ADA Curb Ramp New Construction Inspection Form (Combination)

NW 307th

23885.56

NW Kaybern

COMBINATION RAMP (C)

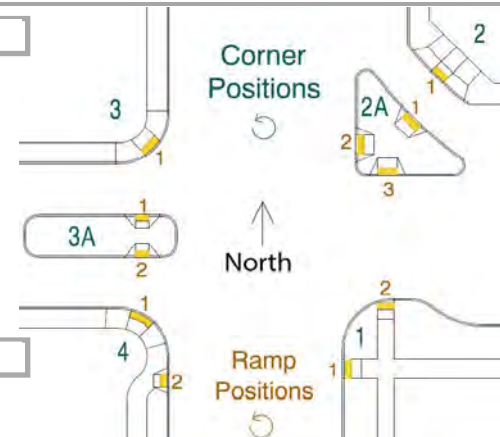
7.1

7.3

24.5

2.2

3.3

DWS IITD, TS Large Crack, Puddle in gutter at Ramp
